FINAL ENVIRONMENTAL IMPACT STATEMENT

Stillwater Mine Revised Waste Management Plan and Hertzler Tailings Impoundment

October 1998

Waste Rock Storage Areas
Figure 2-1

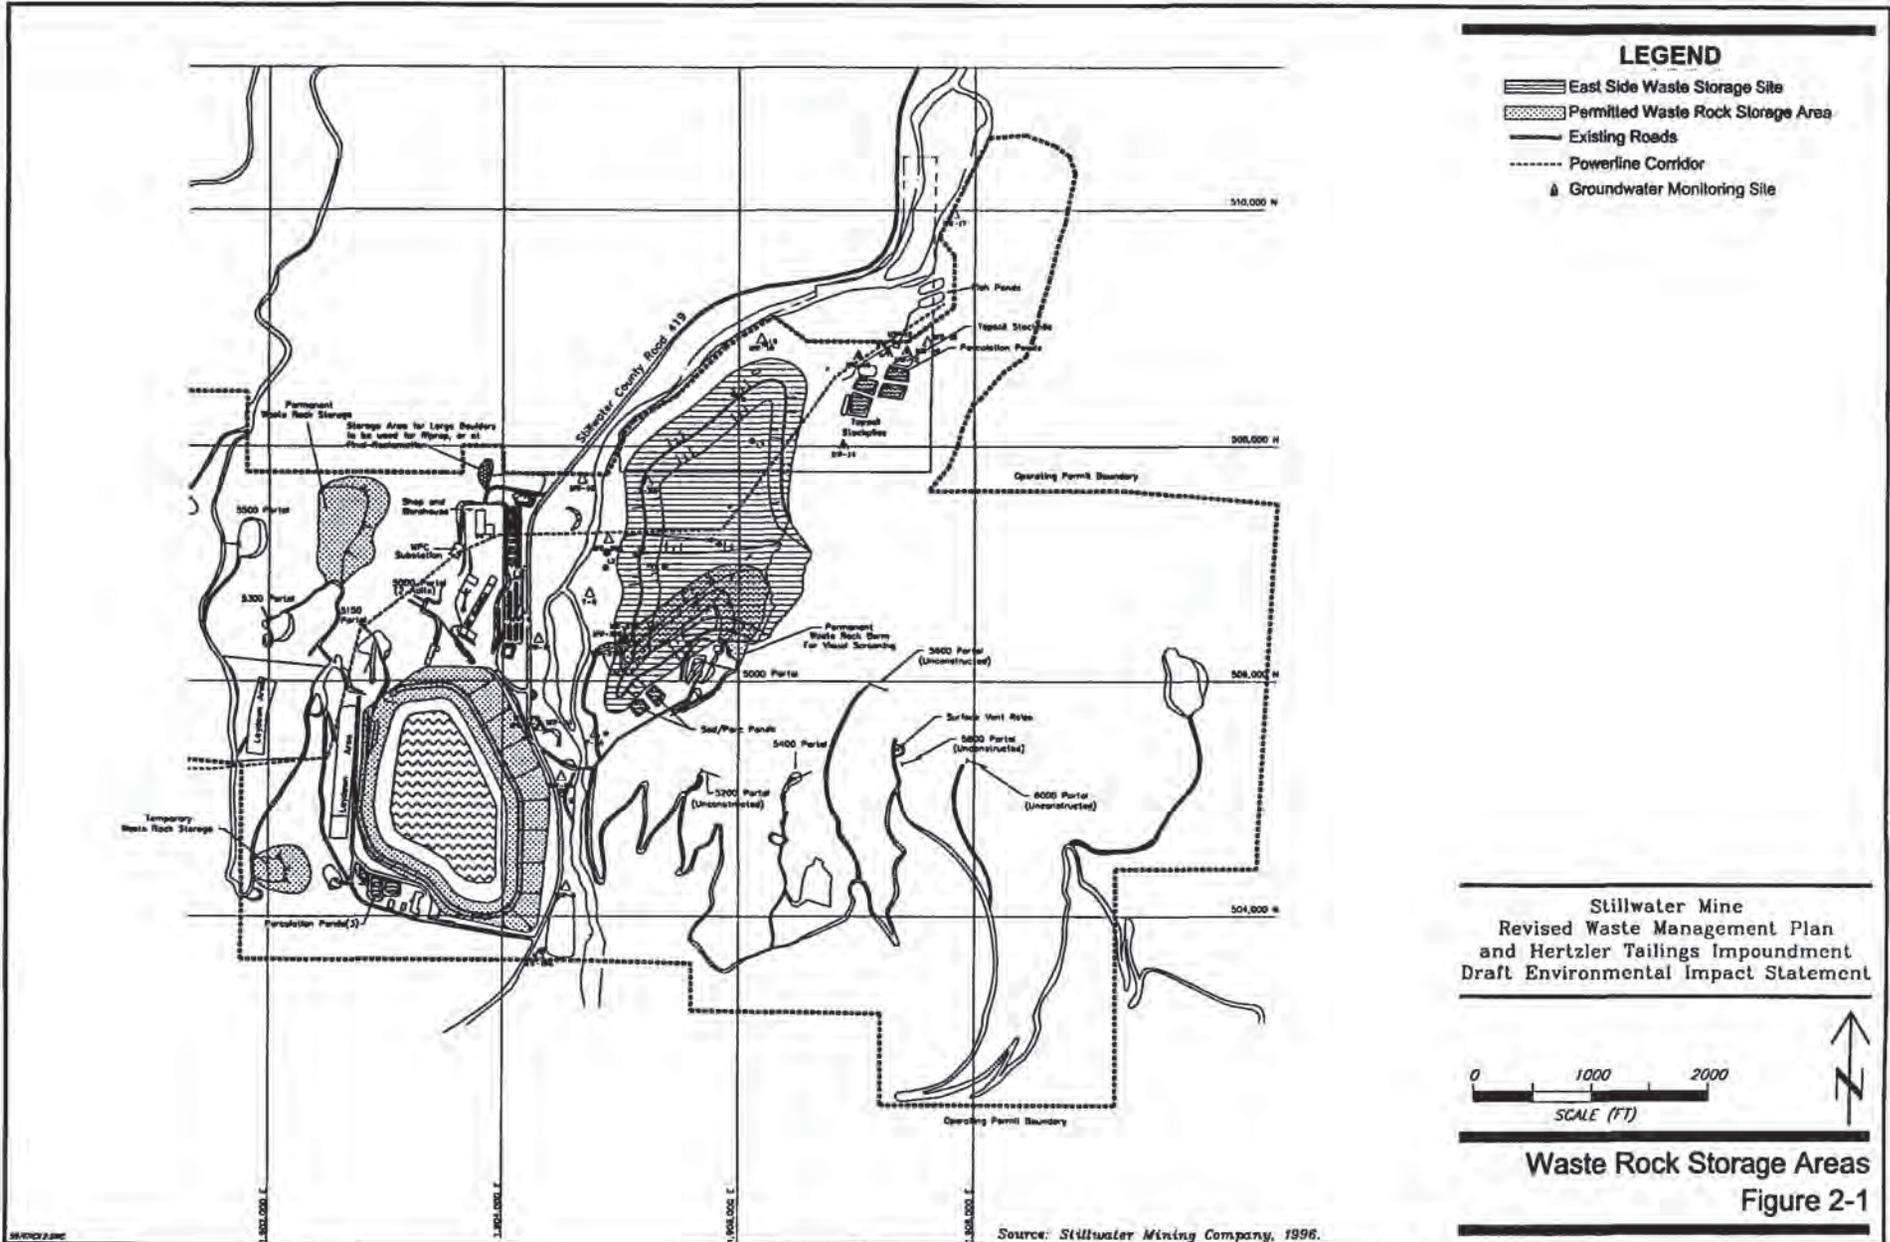
28. *Page 2-15, 2.4.2.1 Waste Rock Production and Management: Waste rock is to be placed in four areas (Figure 2-1). What is the rock content in the fifth area near the shop and warehouse. (32)*

Response: The waste rock disposal area near the shop and warehouse is one of the four areas described in the EIS (near the 5300 west portal). The smaller area near the shop and warehouse is for temporary storage of larger rocks to be used for riprap or reclamation as described on **Figure 2-1**.

Alternative B
Location of Primary Facilities
Comprising the Proposed Action
Figure 2-2

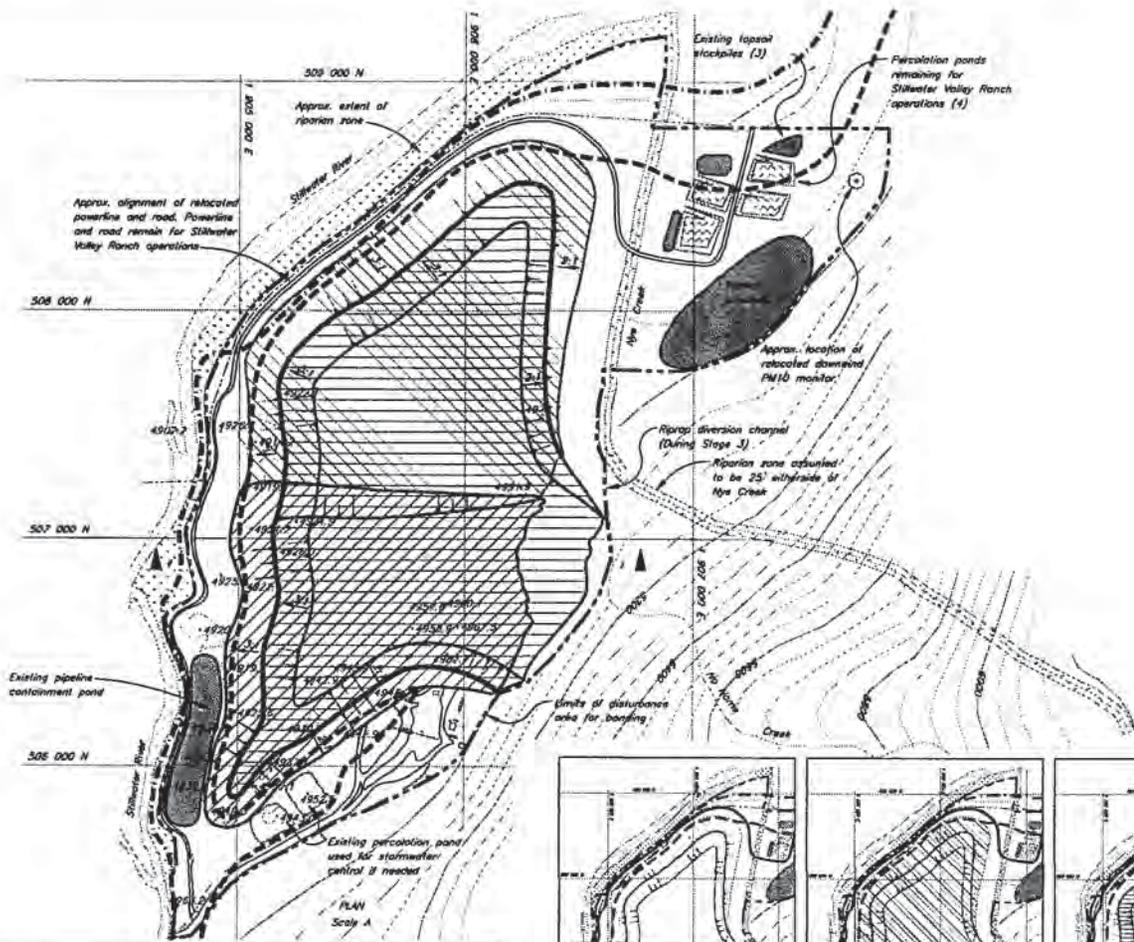
10. *Assuming Figure 2-2 is wrong and 2.4.2.3 is correct, each of the two 800-ft diam. LAD center pivot irrigation systems, operating continuously (24 hrs per day) for 7 months every summer (about 210 days/yr), will produce 300 gpm/pivot. This area receives 15-20 in. precipitation each year. How much additional water does this contribute to the 92+ acres under the pivots and how will this effect those acres? If my computations are correct, each acre under each pivot will receive nearly 290 in. of moisture over and above the annual precipitation, not accounting for evaporation between the spray head and the ground or wind. Given this much added water to these two sites, it seems very certain ground water will mound under the area and that instability of the toe of the colluvial material will occur. It is not a "should ground water mounding" occur issue. What are the consequences of the resulting instability and how might SMC control it? (9)*

2. Figure 2-2. This comment essentially applies to all location of facilities maps. One cannot distinguish between the Borrow Areas and the Waste Rock Storage Areas. Nye is not identified, nor is either the Stratton or the Hertzler Ranch. County Road 420 is not labeled. The legend should include buildings which appear as little brown and somewhat larger black square dots. None show the power lines, existing or proposed. (9)

The proposed Alternative B, pages S-23, figure S-2 shows the overall locations of the primary facilities comprising the proposed action alternative. Figure S-2 does not show the location for the LAD system referred to. However figure S-3 does show the proposed location as it overlaps the access road to the 2 rental homes. (15)

Response: Figure 2-2 has been corrected to show the proposed LAD pivots.

Response: The LAD sites have been added to Figure 2-2.

Hertzler Impoundment Typical Cross
 Section of the Embankment
 Figure 2-5

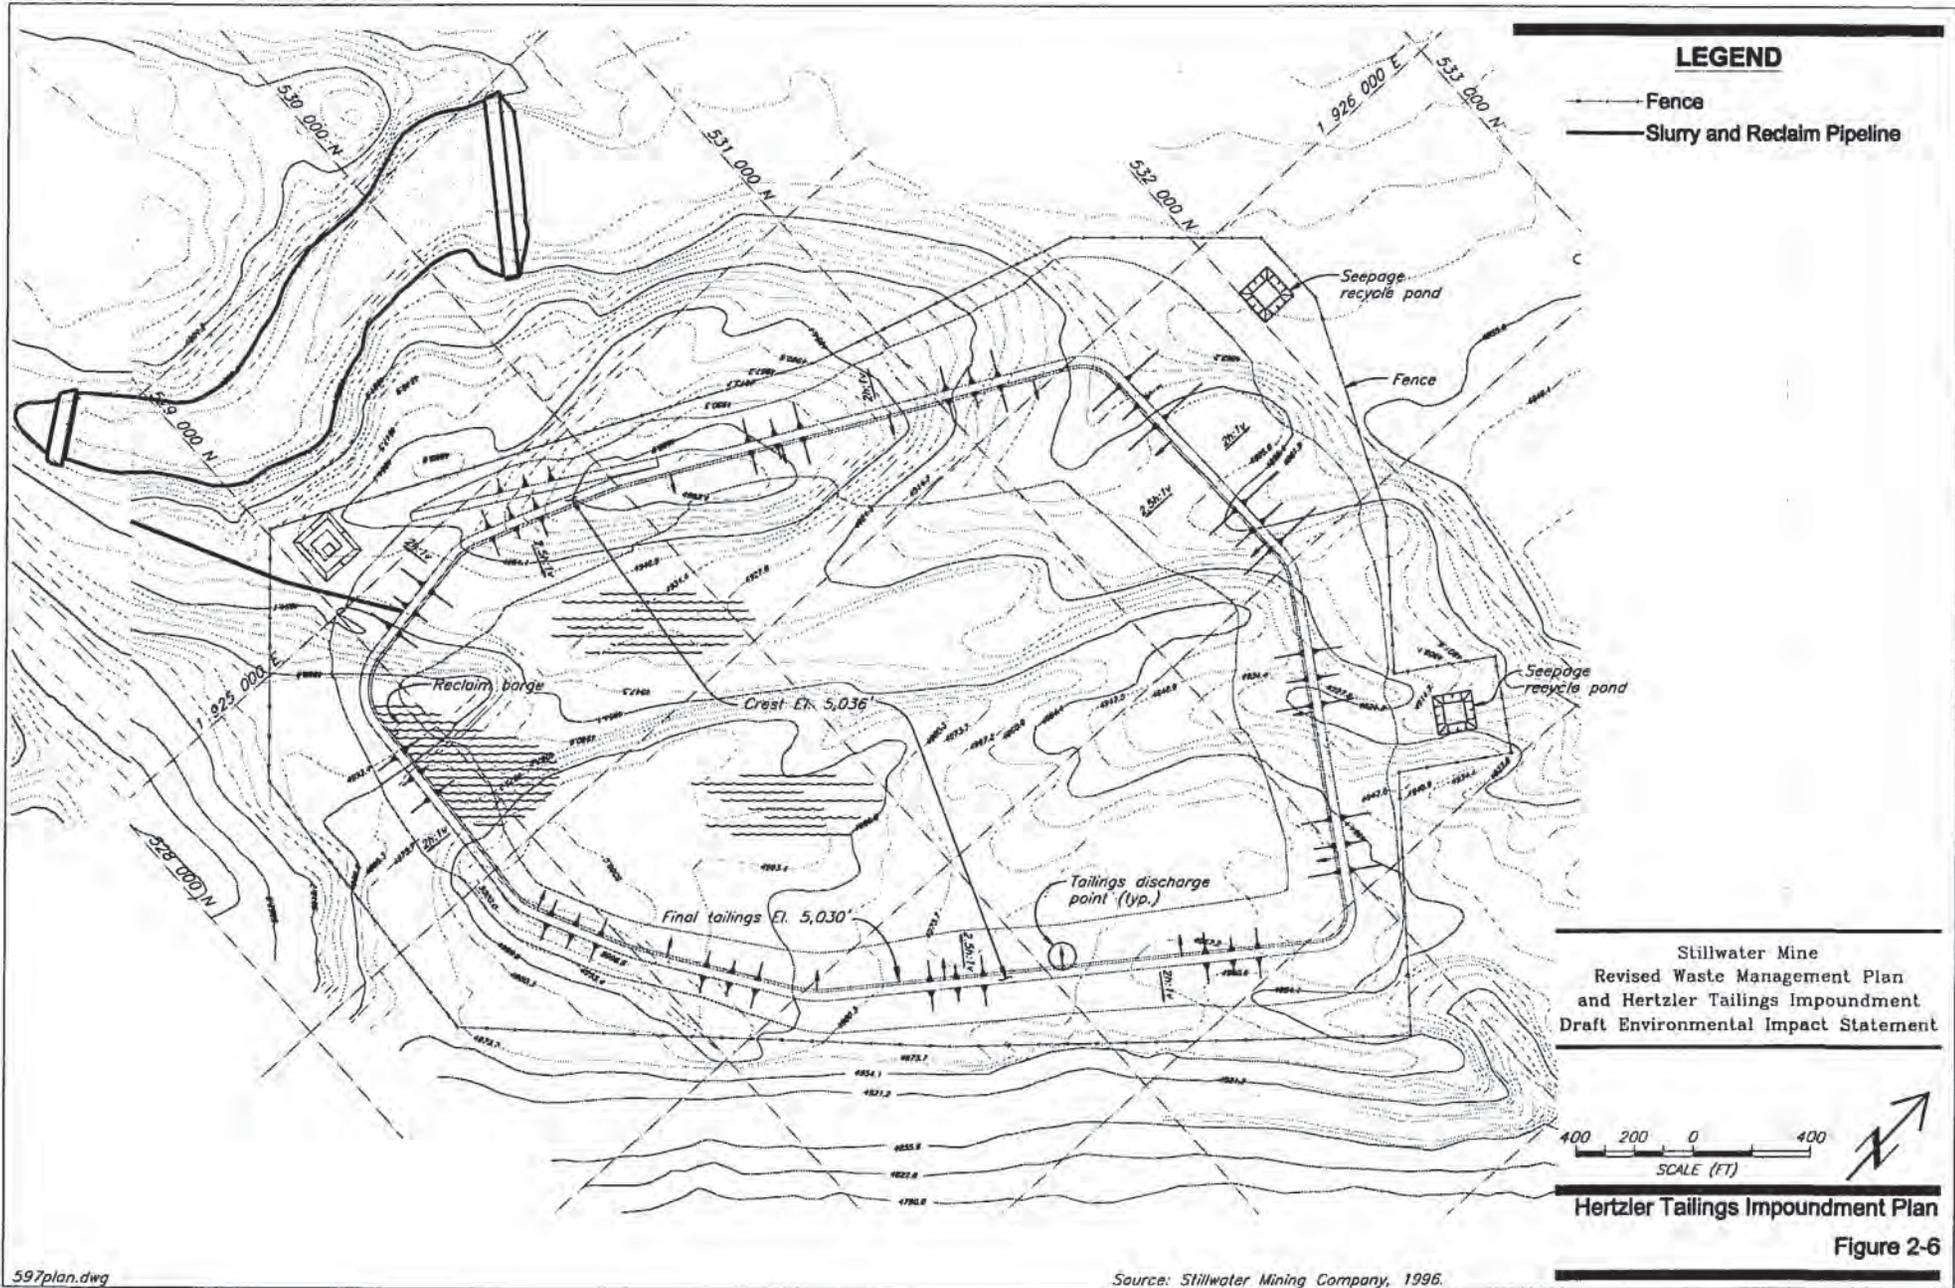
6. Figure 2-5 shows the design for the embankment of the Hertzler tailings impoundment. The upstream slope, facing the interior of the impoundment will have a slope of 2.5H:1V. The downstream side of the embankment is proposed with a slope of 2H:1V. While a 2H:1V minimizes the area covered by the embankment, revegetation of a 2H:1V slope is generally considered to be problematic. (22)

8. *Figure 2-5 shows the design for the embankment of the Hertzler tailings impoundment. The upstream slope, facing the interior of the impoundment will have a slope of 2.5H:1V. The downstream side of the embankment is proposed with a slope of 2H:1V. While a 2H:1V minimizes the area covered by the embankment, revegetation of a 2H:1V slope is generally considered to be problematic. (22)*

Hertzler Tailings Impoundment Modified
 Cross Section of the Embankment
 Figure 4-8

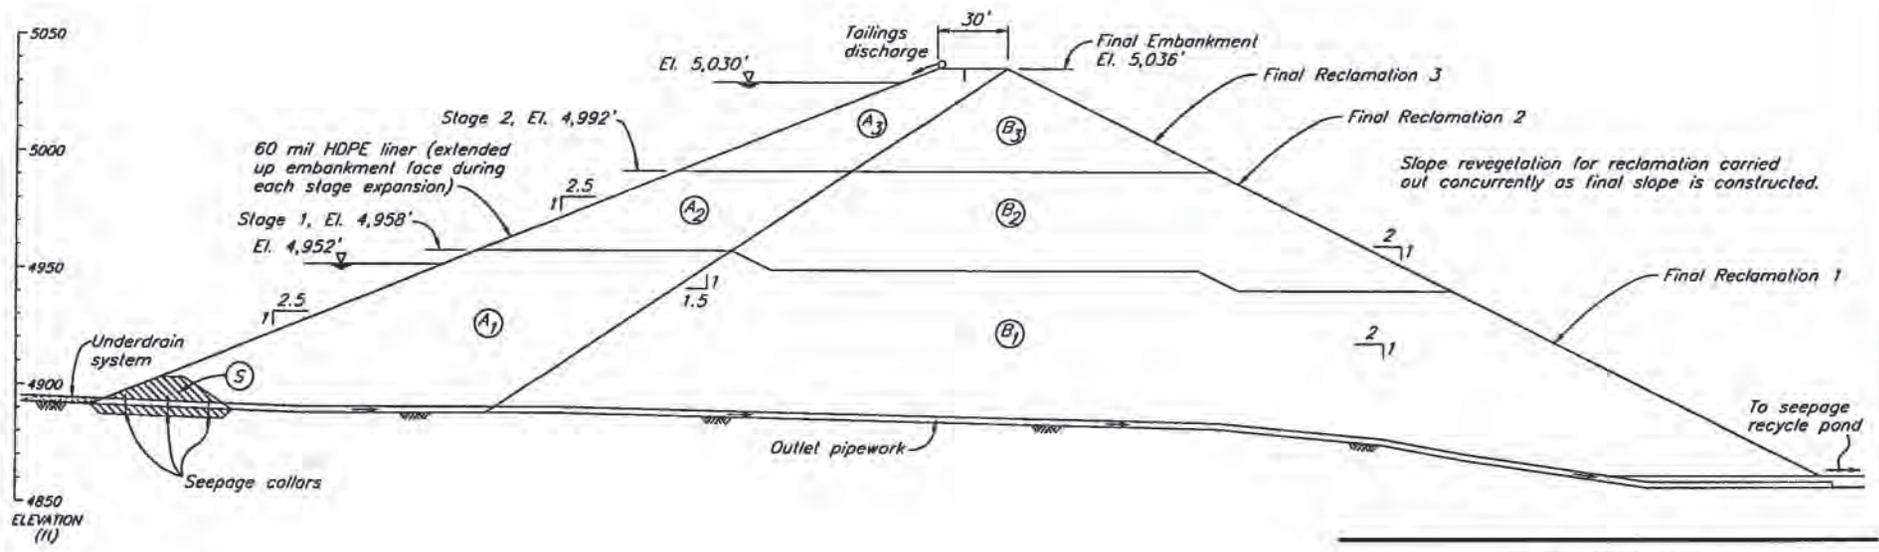
Modifications to the construction of the Hertzler tailings impoundment's embankment (Figure 4-8) would allow final reclamation of the outer slopes to occur soon after they were constructed and would limit redisturbance. This would minimize the visual impact during construction of the second lift.
